Office Action Summary

10/661,195

GOEBEL, STEVEN G.

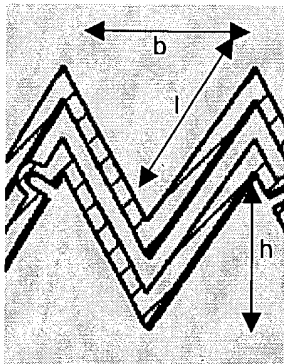
8. Claims 1-5 are rejected under 35 U.S.C. 102(b) as being anticipated by Marianowski (6,261,710). Marianowski teaches a separator plate (applicant's bipolar plate) for a fuel cell. A fuel cell includes a membrane-electrode-assembly (MEA) composed of an anode, cathode, and electrolyte. The separator plate is disposed between the anode of one MEA and the cathode of an adjacent MEA. The separator plate is constructed of two sheet metal elements (applicant's first and second sub-plates) with identically shaped guide means that are nestled together to form a coolant flow space between the elements. As

seen in Figure 3, the corrugations (60a, 60b) form a plurality of flow channels for distribution of the reactant gases, fuel and oxidant, to the anode and cathode electrodes, respectively. The corrugations are laterally centered at a distance from each other to form coolant flow channels. The surface area of the coolant flow channels is greater than the surface area of either reactant flow field (see sample calculation below), and the height of the coolant flow channels is substantially the same as the height of either reactant flow field. (Col. 2, ll. 12-62; Col. 3, ll. 52-63)

Considering as an example one pass of a straight channeled flow channel, as illustrated above, where d is the distance between the corrugations and w is the width of the flow channel:

$$\text{Surface area of reactant flow field: } A_{s,r} = 2wl = 2w \sqrt{h^2 + (0.5b)^2}$$

$$\text{Surface area of coolant flow field: } A_{s,c} = 4wl = 4w \sqrt{h^2 + (0.5b)^2}$$

$$A_{s,c} > A_{s,r}$$
